Application for Works Approval

Works Approval Number W3048/2025/1

Premises Murrin Murrin Nickel Cobalt Project

Date of report 7 January 2026

Figure 1: Proposed 8 Series Inpit TSF and pipeline layout

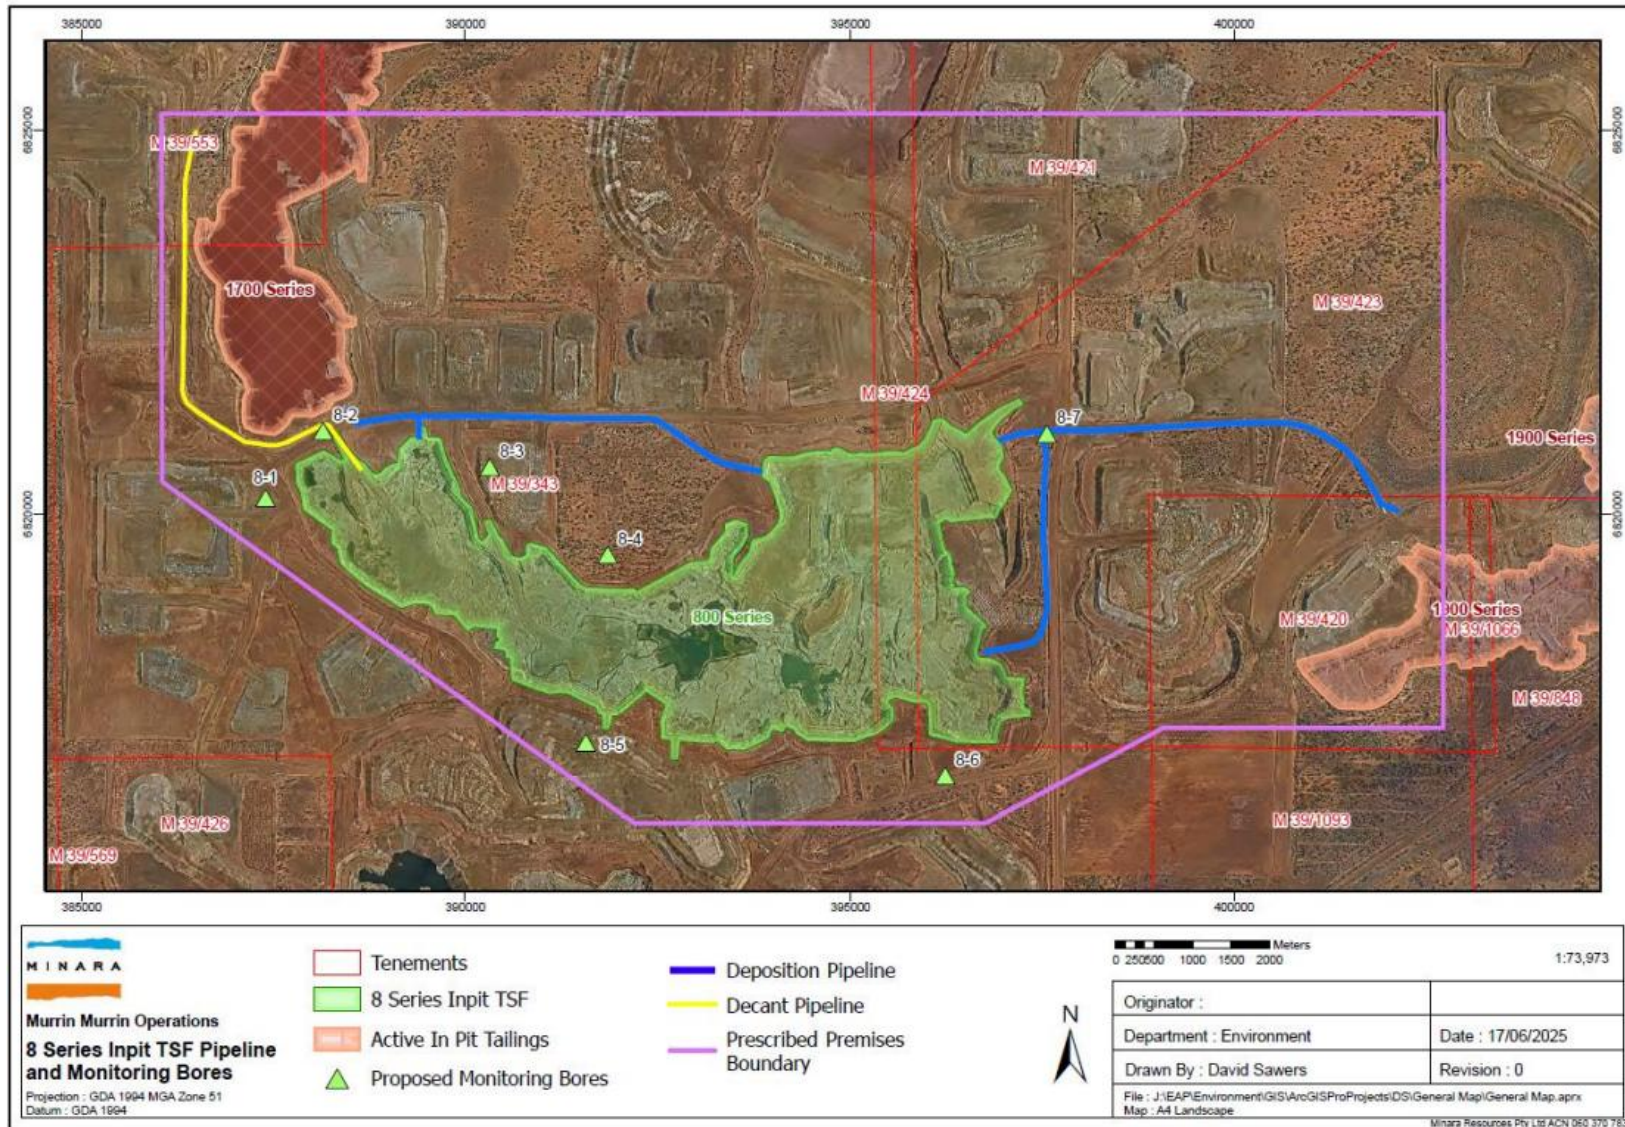
Existing monitoring bores at the site were originally designed to allow conversion for seepage recovery if required. However, the department has advised that monitoring bores should remain separate from seepage recovery bores to maintain the integrity and reliability of monitoring data.

In response, the applicant proposes installing seven additional monitoring bores around the 8 Series Inpit TSF at the locations shown in Figure 1. These locations have been selected to provide adequate space for the potential future installation of seepage recovery bores, if necessary. No seepage recovery bores are proposed at this stage; however, the applicant may install one in the future should significant seepage requiring active management occur.

The department's Contaminated Sites Branch has reviewed the proposed bore locations and considers them appropriate, given that deposition into the 8 Series Inpit TSF has not yet commenced. Additional monitoring bores may be required in the future, as outlined in section 3.3 of this decision report.
